CARLYLE COMPRESSOR DIVISION

×	PRODUCT	☐ GENERAL	☐ SERVICE & PARTS
Dat	te: 13 February, 2003	Number: 03T-1	Issued By: P. Tollar
Subject:	Update 06E & 06T	Terminal White fact	racetone (
Product Nam	e 06E & 06T		
.

This bulletin is updating the terminal wiring instructions to all 06E, 06CC (E-body) semi-hermetic and 06T screw compressors. This bulletin is meant to clarify OEM bulletins #113 (dated 4/4/88) and 98T-1 (dated 3/25/98) that included our prior wiring instructions. We have also increased the recommended torque of the jam #3 used to tighten the field power wires.

FIGURE 1: 06E, 06CC & 06T TERMINAL BOX & WIRING

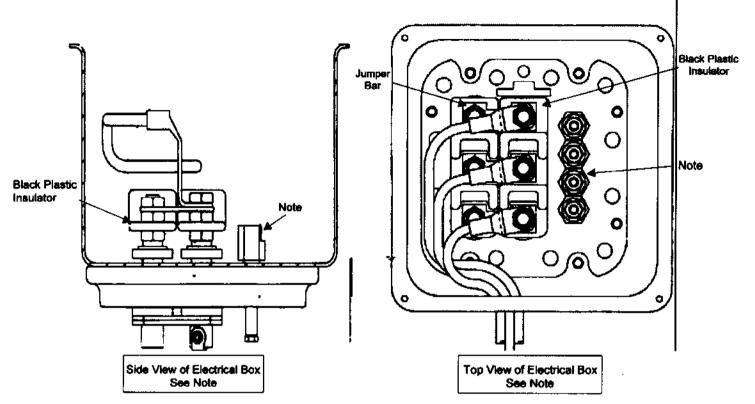
- Allowed on any terminals where a jumper bar is used over jam nut #2 (See figures 1 thru 7 attached). This allows the increased torque to any across-the-line wiring arrangements shown in attached figures 3 & 4 on all current and older compressors.

- Terminals T4, T5 & T6 will always have a jumper bar applied with them. Therefore higher torque
 can be applied without adding any loctite. These terminals may also have the plastic isolator
 removed to add the 3-hole jumper as shown in Figures 4 & 7. Loctite will not be applied to these
 terminals at Carlyle for this reason nor is it recommended in the field.

The purpose of this change is to ensure the power wiring is secure in the field. Our 98T-1 Bulletin recommended up to 12 ft-lbs torque to tighten the power wiring (jam nut #3). We are now increasing this torque up to 18 ft-lbs max and dropping our requirement of adding loctite to the #3 jam nut. This increase in allowable torque is based on the following limitations:
